Docket Nos.: 50-361/362

Subject: Long Term Operability of Deep Draft Pumps

GUIDELINES FOR DEMONSTRATION OF
OPERABILITY OF DEEP DRAFT PUMPS

Figure 1

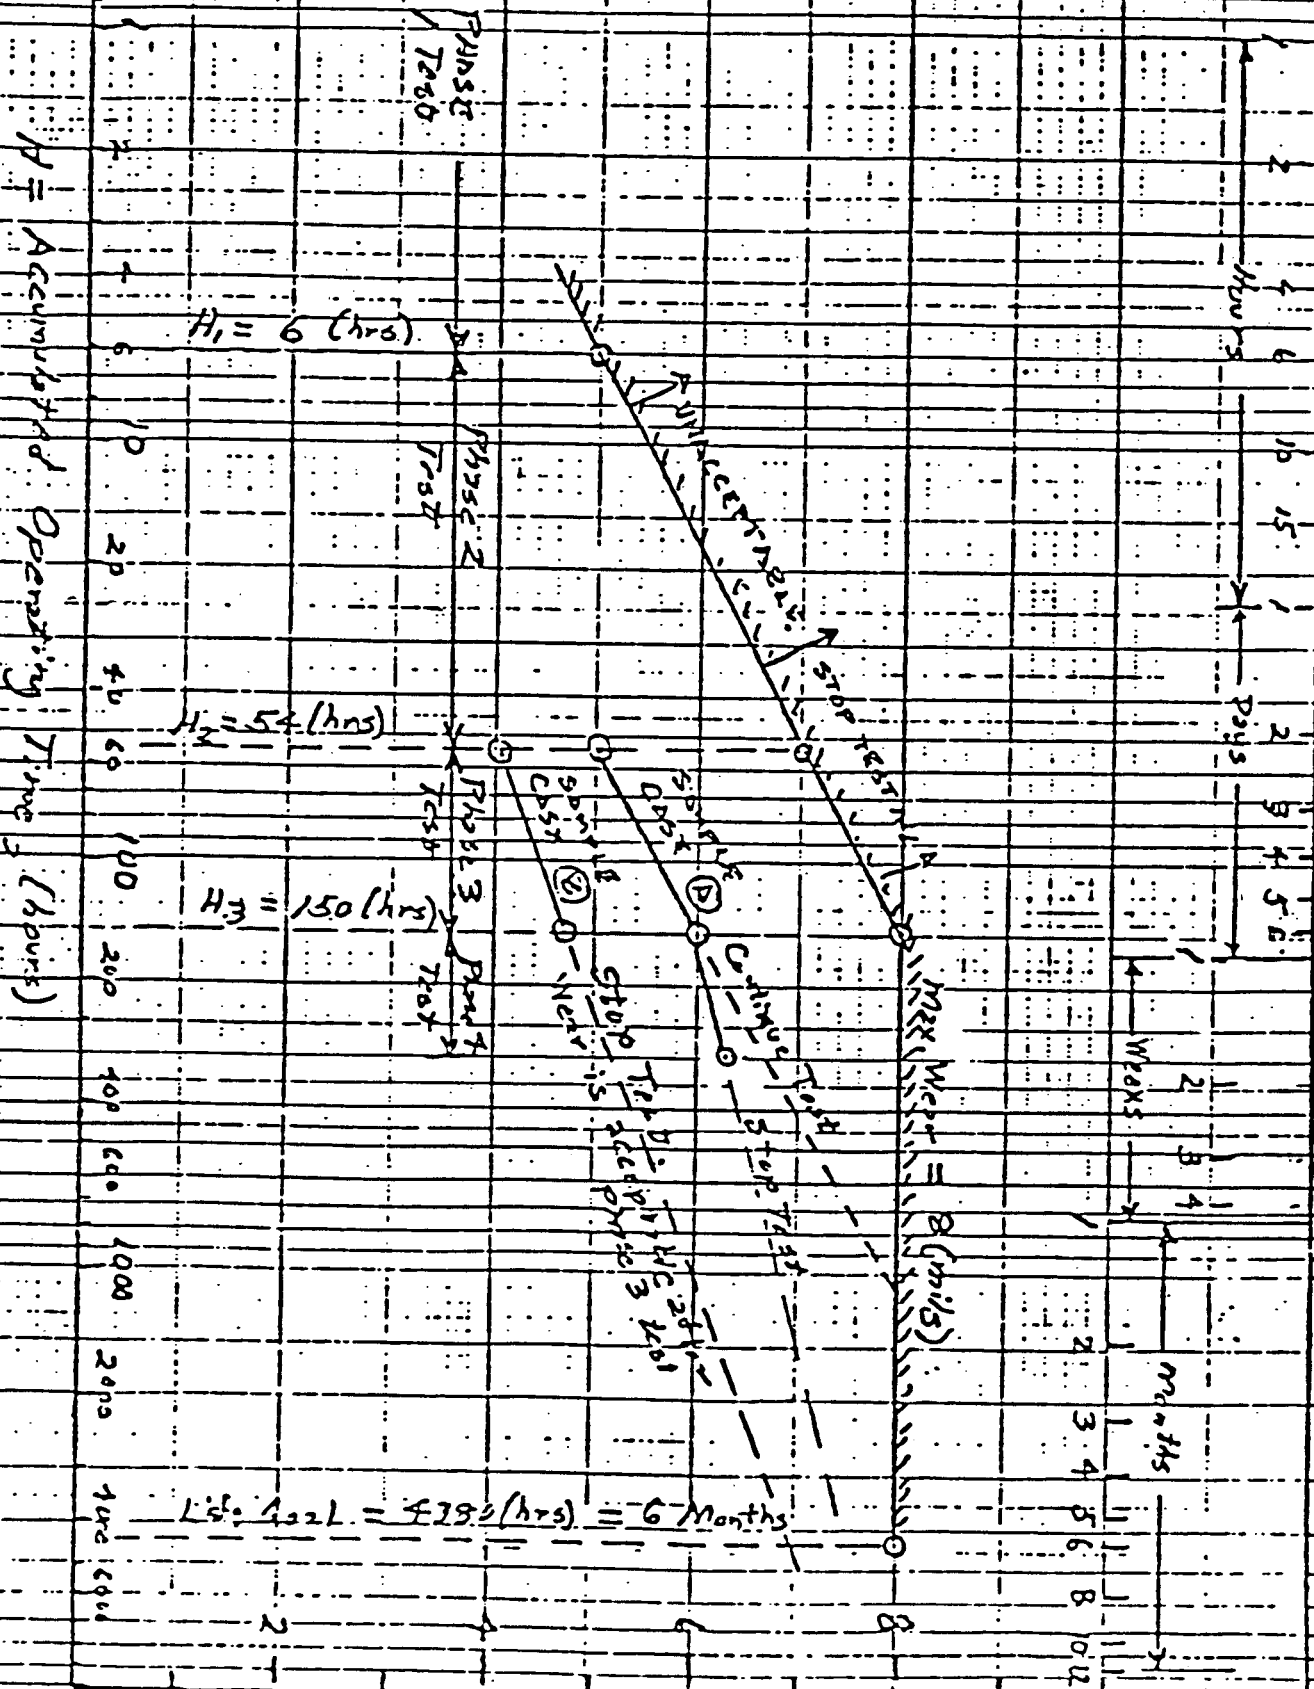
Plot the values of accumulated wear versus time (H) for each bearing after Phase 2 and Phase 3 tests, namely.

Straight lines are then drawn through the plotted values of wear and extended to the right (See example Figure 1). If the extension intercepts the maximum acceptable value of wear (8 mils) at a value H less than the life goal for this pump, additional testing should be performed. If the intercept of the line with wear of 8 mils exceeds the life goal for this pump, no additional testing is required and bearing wear is acceptable. If additional testing is deemed necessary it should be done in a similar manner to that performed during Phase 3 with similar acceptance criteria and decision process. It is expected that such additional testing will either show a stable pump operation with no increase in bearing wear or increased bearing wear with unacceptable results.

- 1.) If accumulated bearing wear is > 8 mils for any bearing,³ wear is unacceptable and test should be terminated.
- 2.) If accumulated wear is < 8 mils for all bearings,^{3a} decision needs to be made to establish:
 - a.) the need for additional testing or
 - b.) whether or not the bearing wear will be acceptably low.
